John's broken antenna

Connection Problems

Figure 1 Multiple wiring and hardware errors

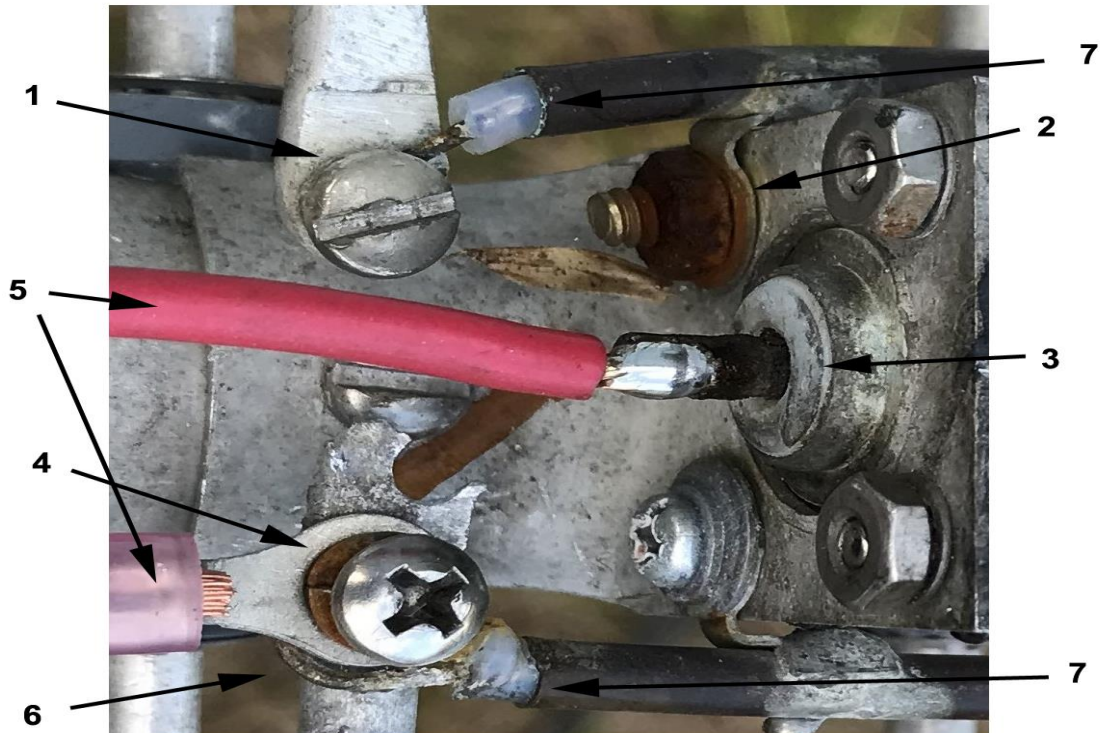
- 1.) Wires under screws with no lug or proper flat washers to sandwich
- 2.) Rusted critical hardware and both lugs technically go the wrong direction. Ideally grounds should be at the coax ends
- 3.) No weatherproofing, often will leak
- 4.) Wrong hardware and rusted hardware
- 5.) Wire crimped and far too long. Outdoor wire connections should be soldered or clamped, not crimp lugs
- 6.) Wire under the wrong hardware
- 7.) No water leak sealing or protection

Figure 2 Symmetry error

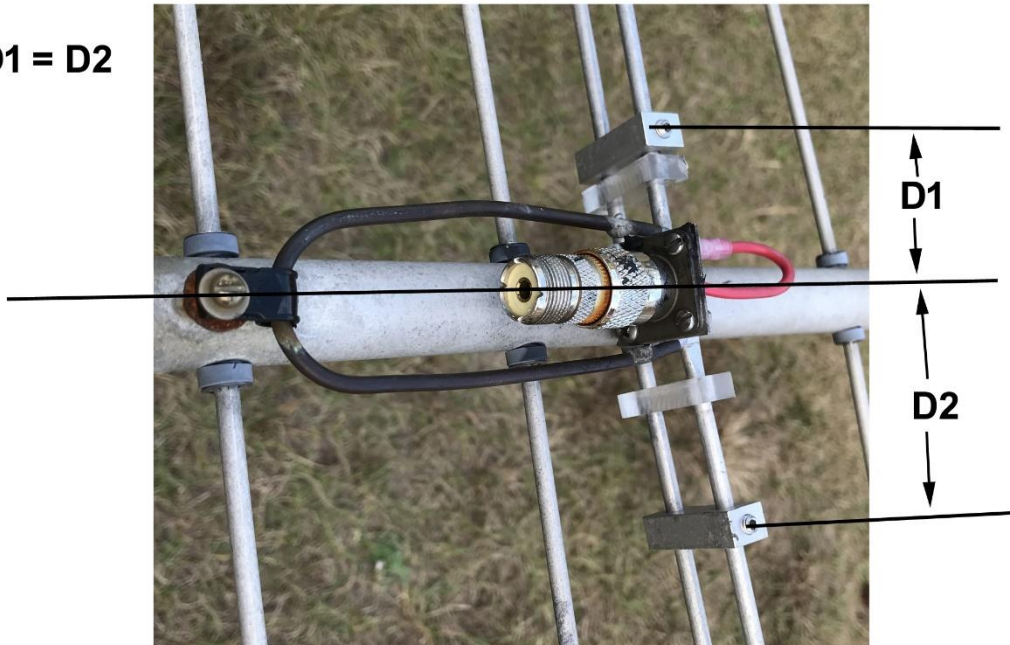
1. D1 and D2 are not equal
2. Multiple other connection problems

T-match should be kept symmetrical to centerline

D1 = D2

Figure 3 Wiring

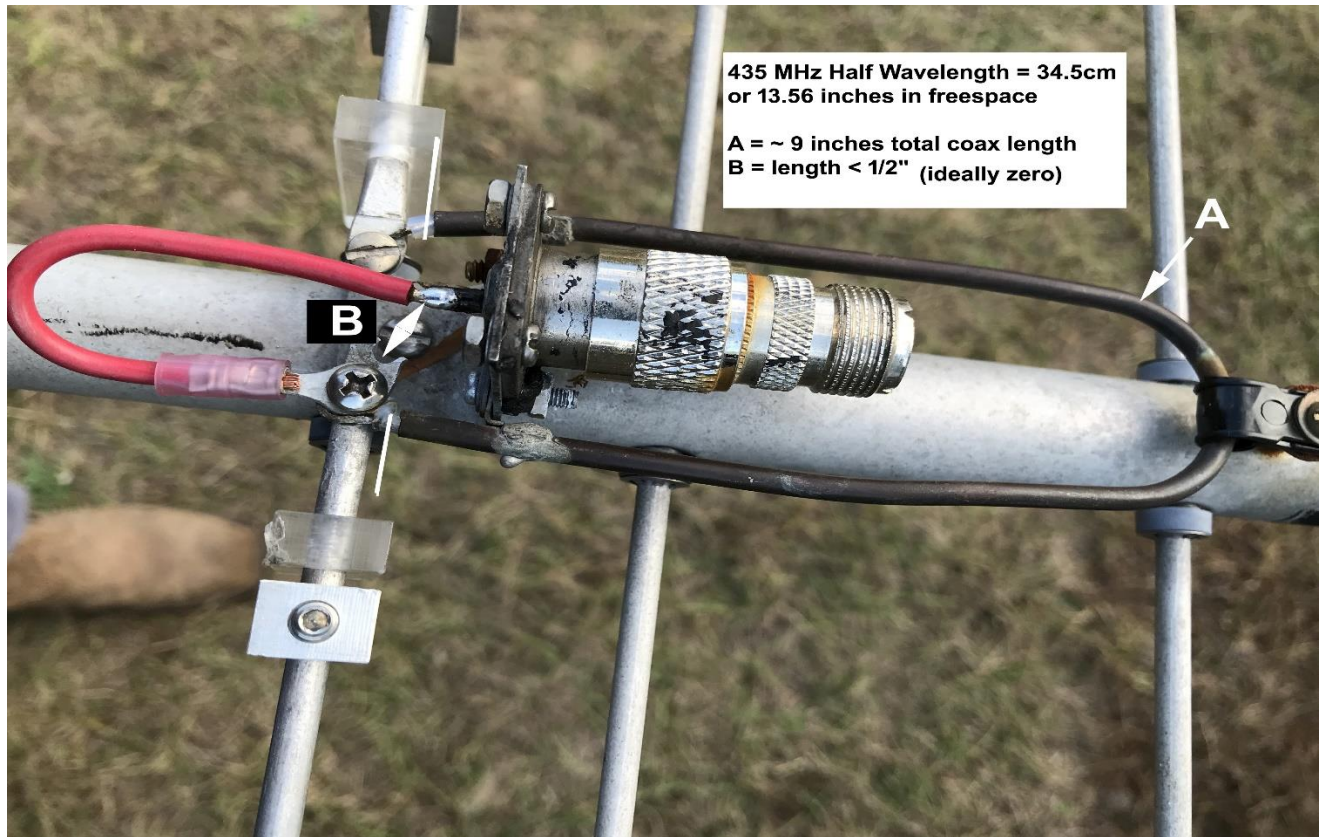
A should be $\frac{1}{2}$ wavelength of a fairly low-loss reliable coaxial cable. The ideal cable impedance is 100-ohm, since each half of the T should look like 100-ohms and have near zero reactance.

B should be as short, wide, and smooth as possible. Plated copper strip or flashing would be ideal, solid wire second best, stranded third best choice and braided last choice. B should be a tiny fraction of a wavelength. Even one inch is too much at 432 MHz. Just one inch of connection length at 432 is like using 110 inches of connection length on 75 meters!!!

The higher the frequency the shorter connections must be.

Figure 6 upper assembly errors

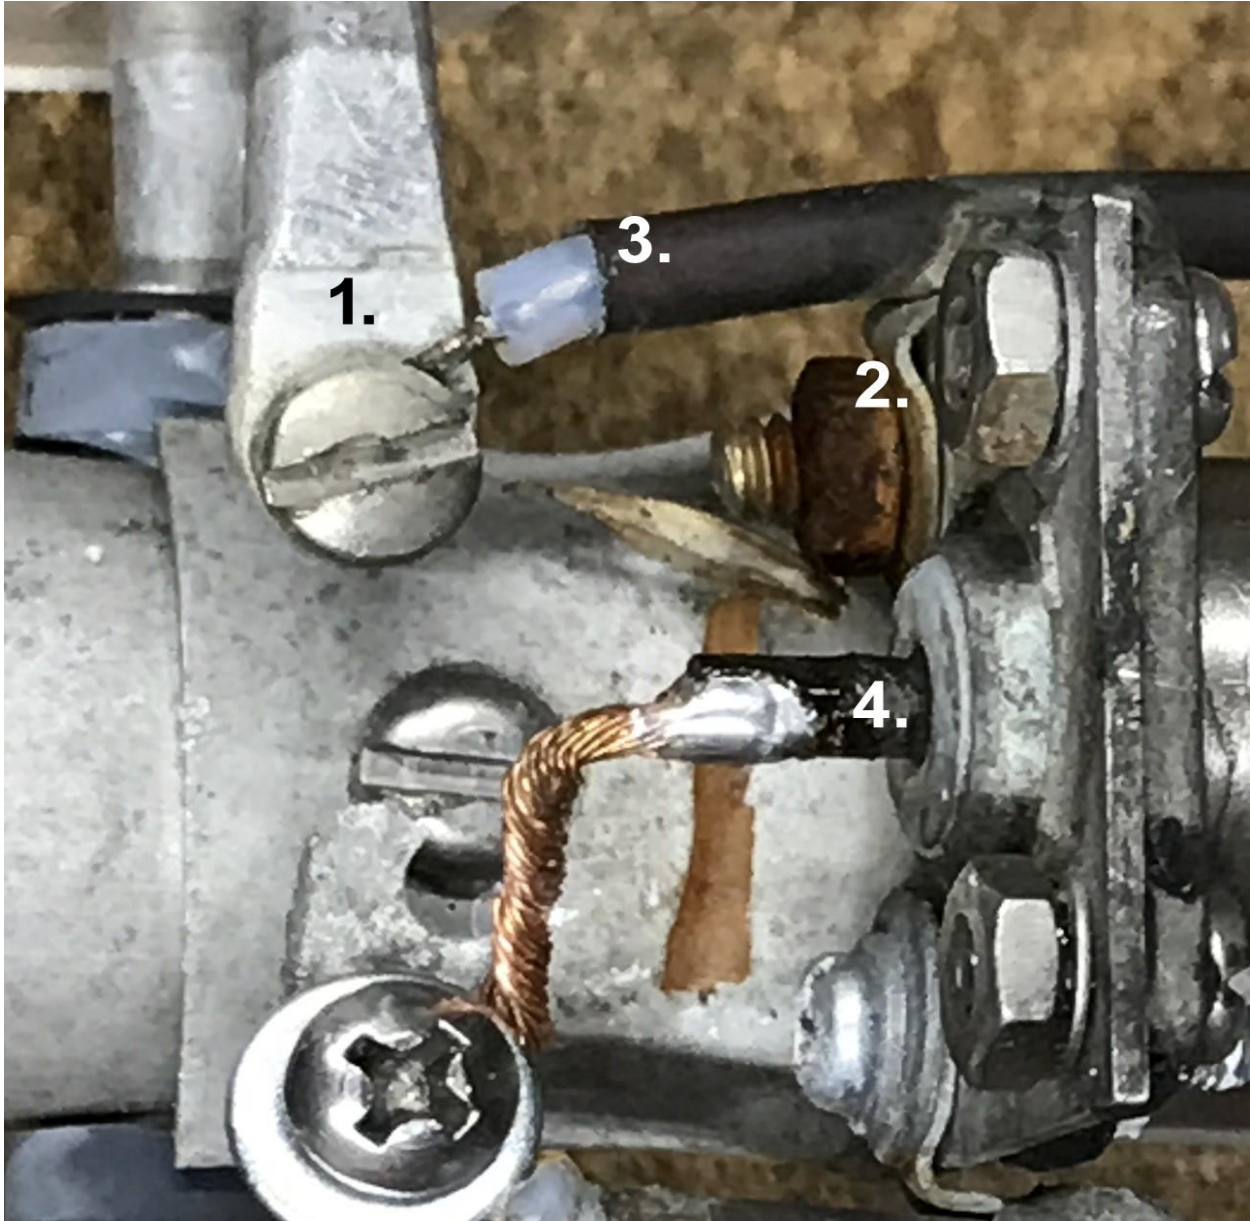
1. Needs new proper hardware. The wire should be between passivated stainless flat washers
2. Rusty zinc-steel hardware must be replaced with passivated stainless
3. Must be sealed
4. Must be sealed and the wire really should have been solid copper or better a wide, flat, plated or tinned copper strip
